**FINAL ENVIRONMENTAL IMPACT REPORT
FOR
THE MONTERRA RANCH SUBDIVISION**

EIR No. 84-007

Subdivision 815

RESPONSE TO COMMENTS

FIGURE 1.2

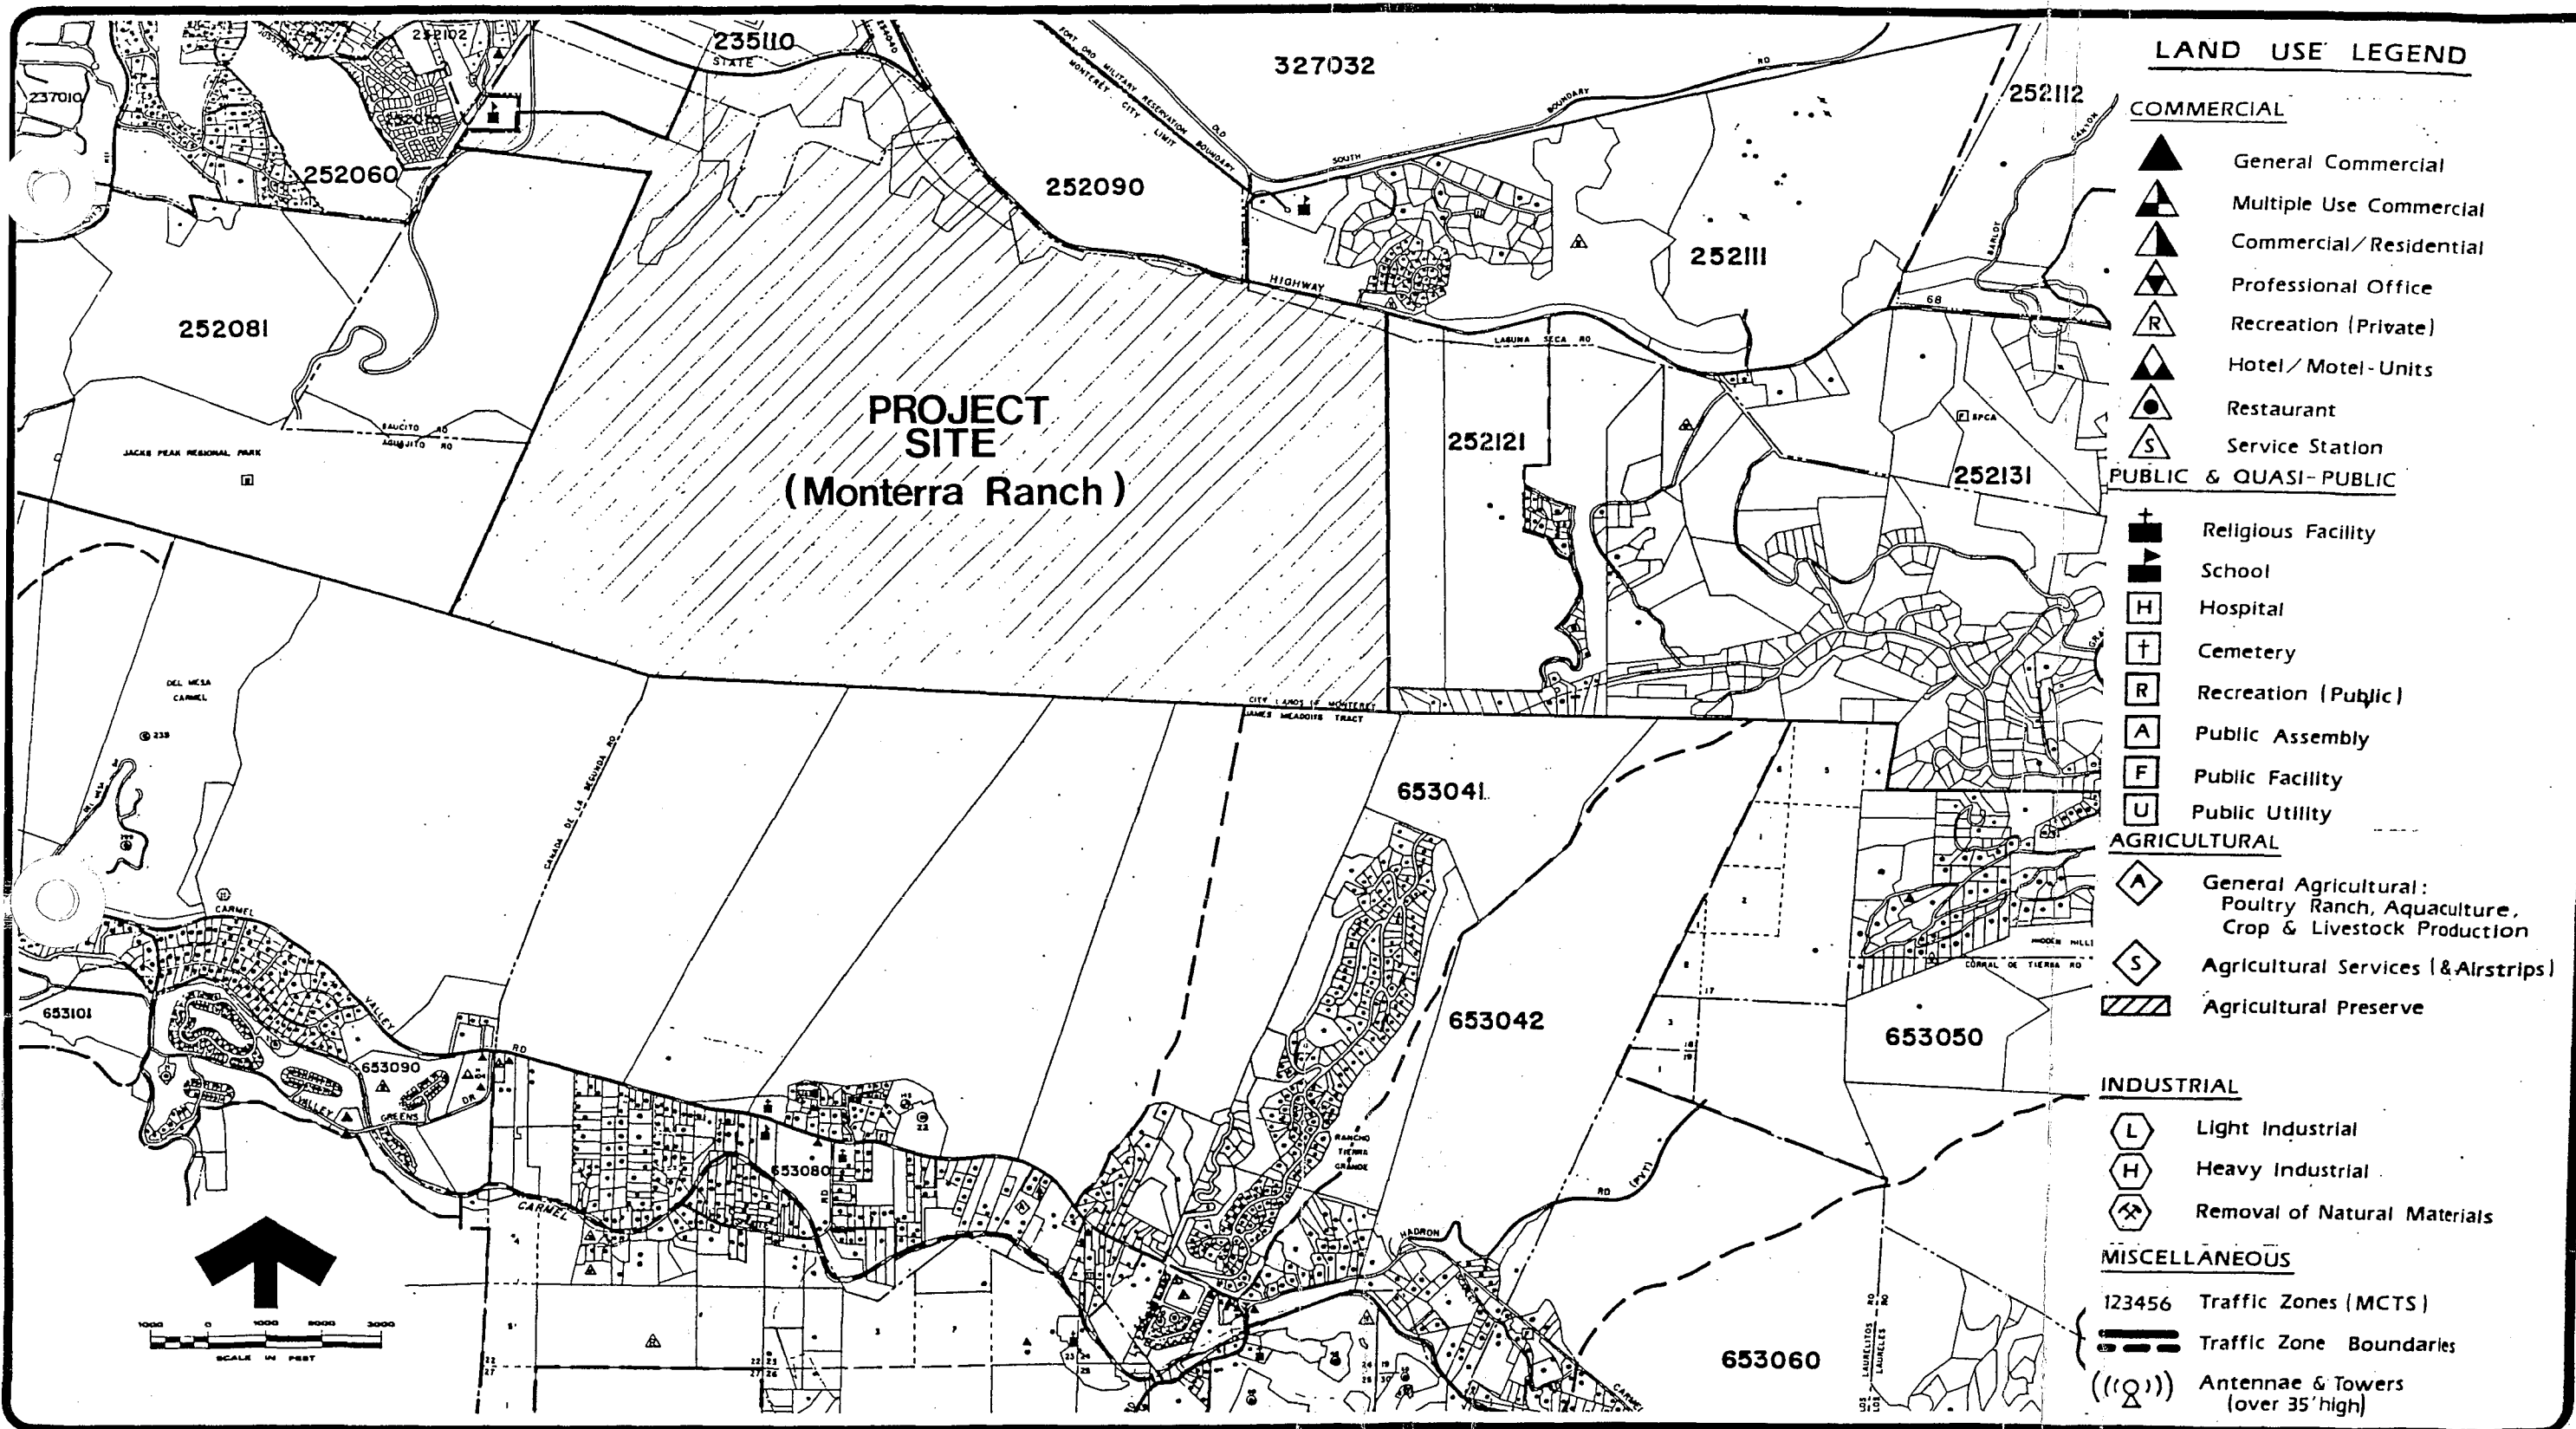
Figure 1.3 should be corrected so as not to include MPUSD (school district) property as part of the project area.

1. Figure 1.3 (follows page 5) shows the project area to include the Monterey Peninsula Unified School District (MPUSD) property, while Figure 1.2 excludes it. It is presumed that this property is not part of the project area; thus, Figure 1.3 needs to be corrected. 24

Figure 1.3 has been corrected.

FIGURE 2.6

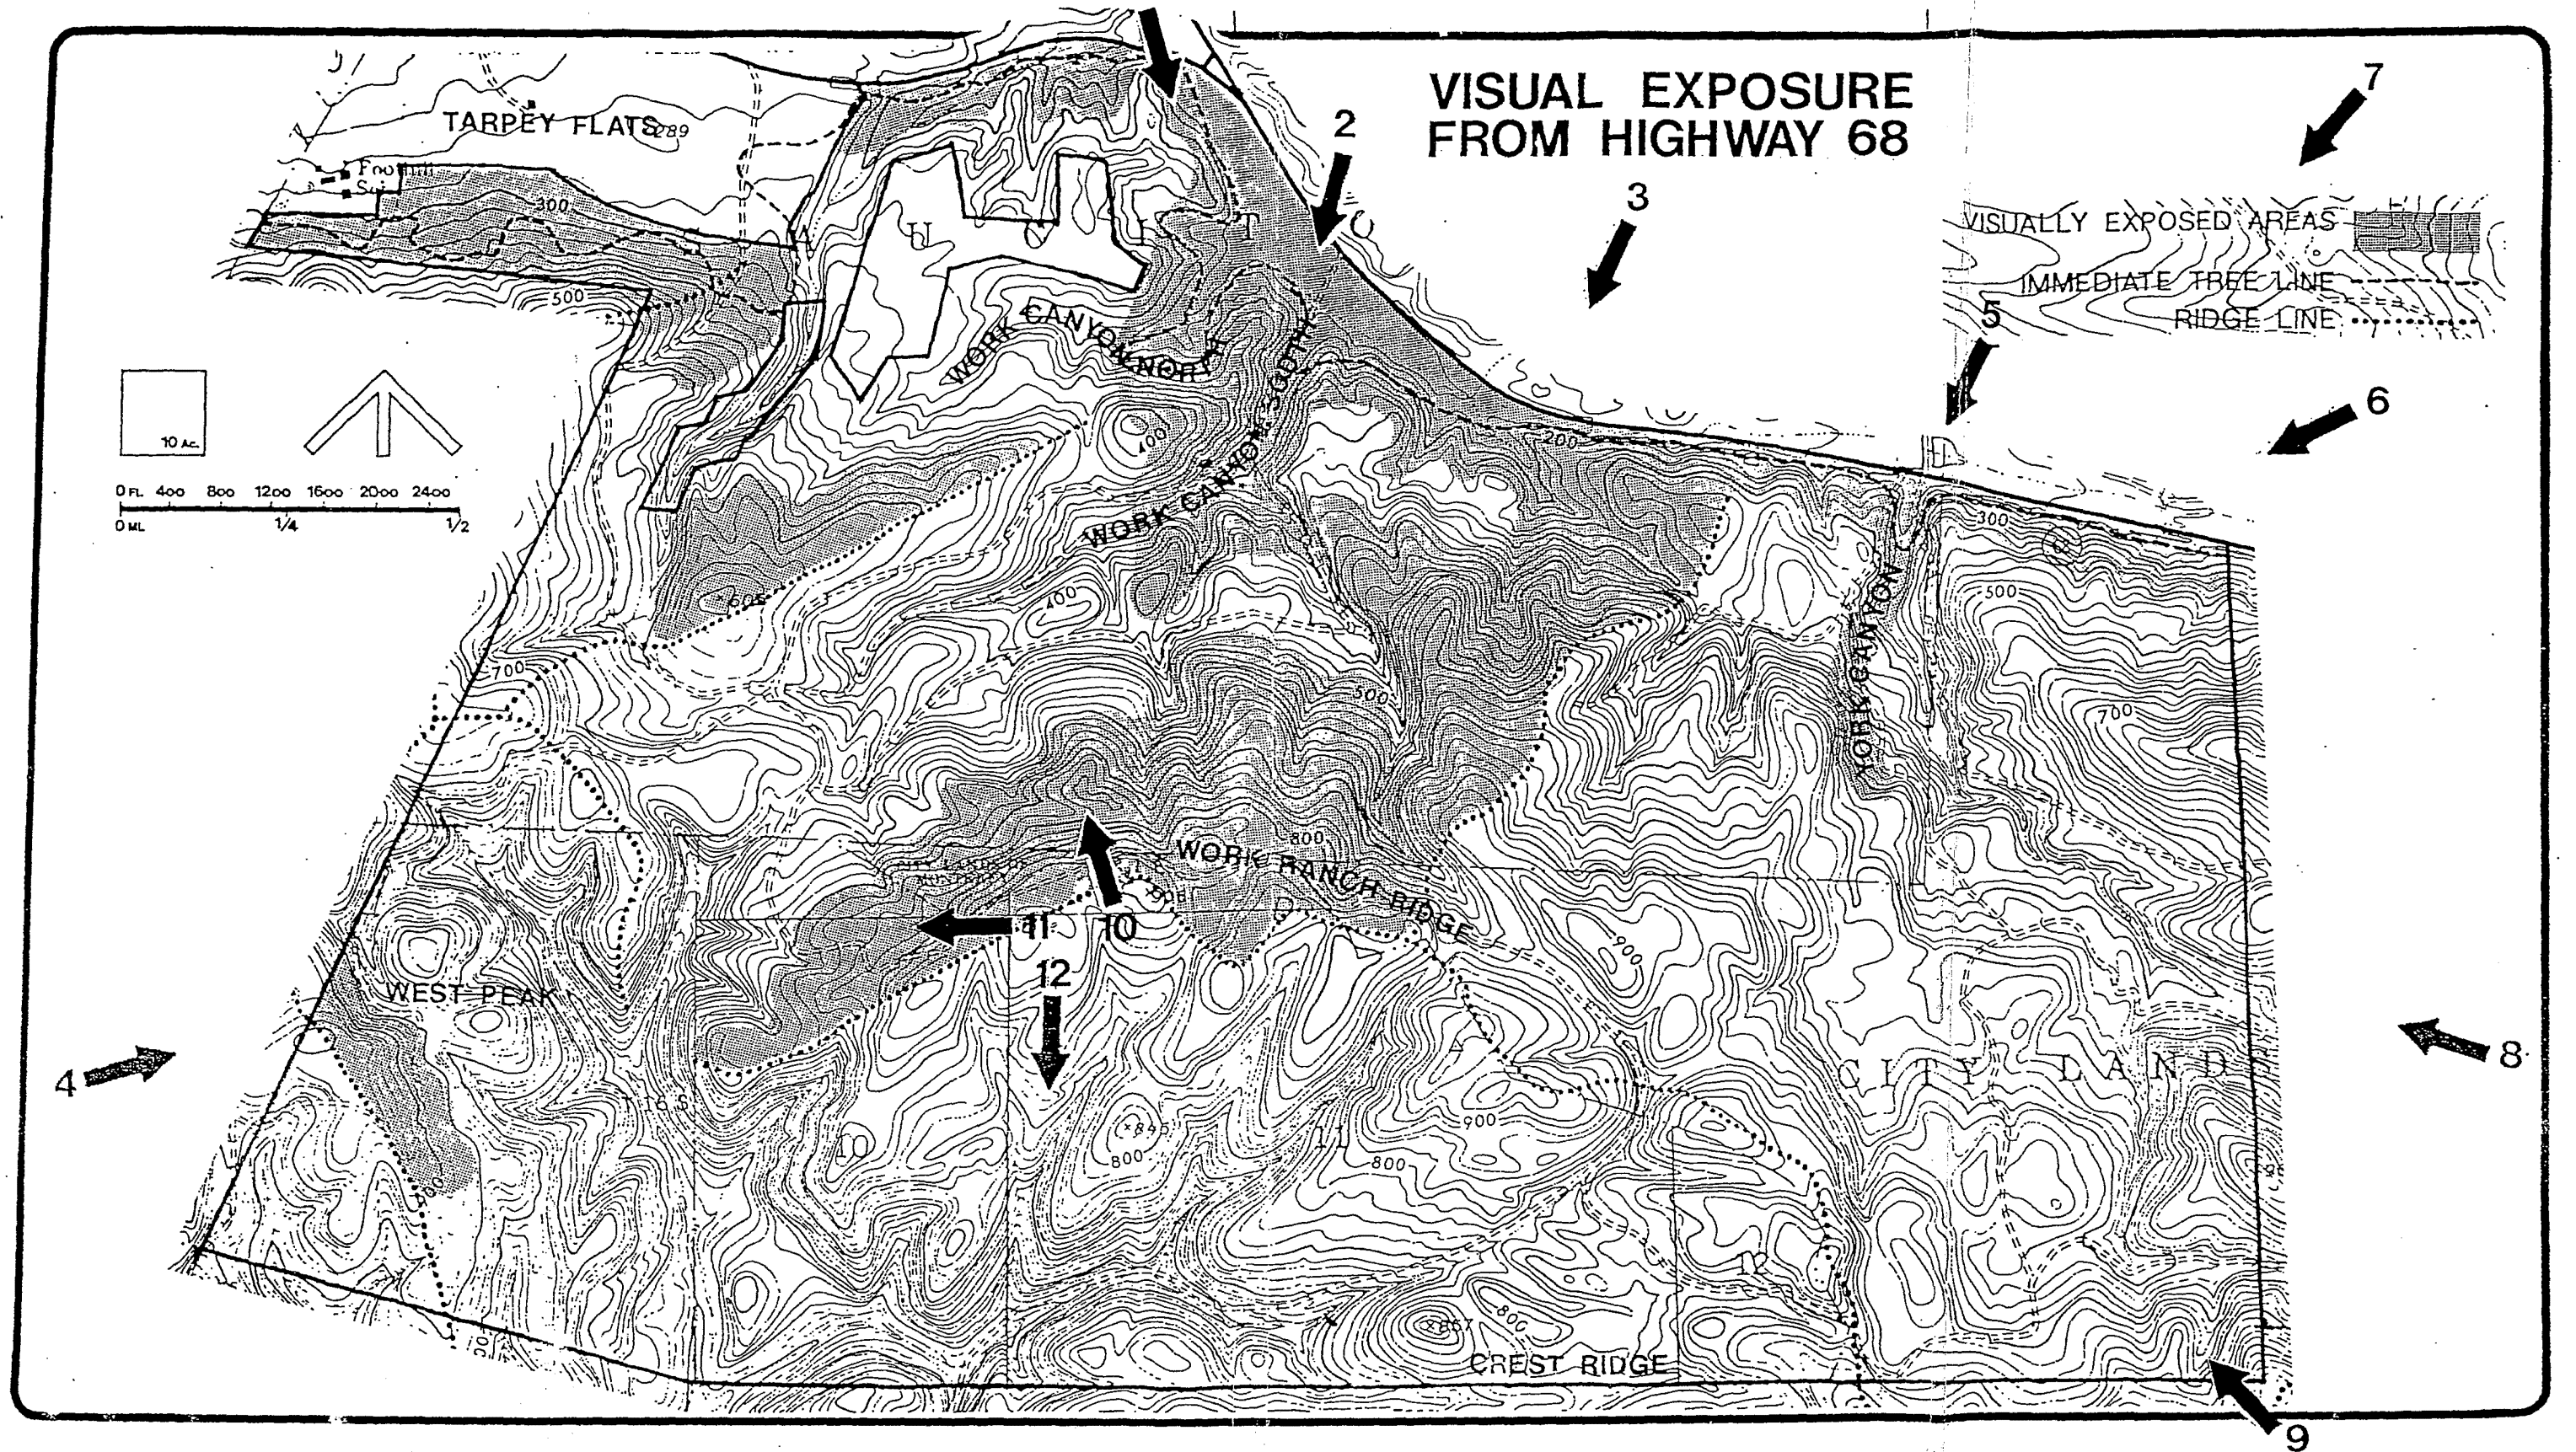
Figure 26 (page 42) does not correctly depict the 100-year floodplain and should be revised for the Final EIR.

On page 42, Figure 2.6 the 100 year flood plain is not depicted accurately and should be revised for the Final EIR.

FIGURE 2.8

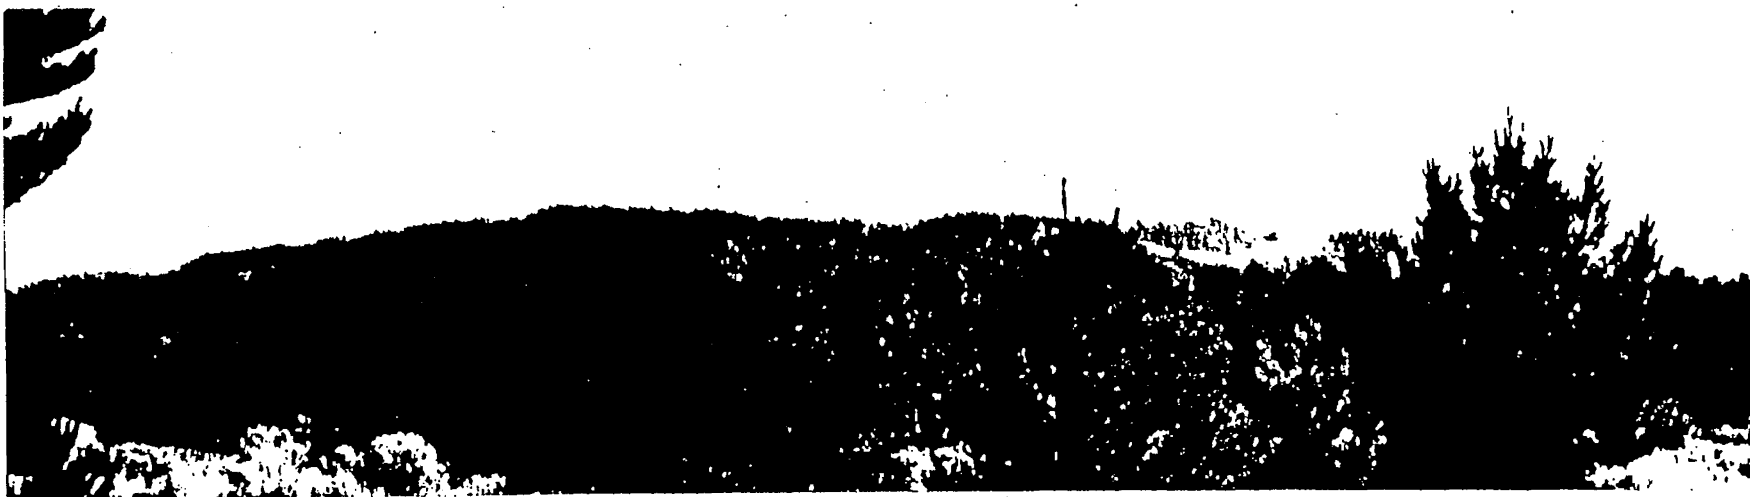
On Figure 2.8, the project site includes land north of the MPUSD site. However, on Figure 1.2, the project site does not include land north of the MPUSD site. Clarification is needed.

7. On Figure 2.8, which follows page 86, the project site's Major Landforms and Visual Exposure from Highway 68 map appear to wrap around the MPUSD site and not include it. Figure 1.2 identifies the project's site as lying south of the MPUSD site and not extending around it to Highway 68 on its north side. Clarification/correction is needed.

This should refer to Figure 2.8. This correction has been made.
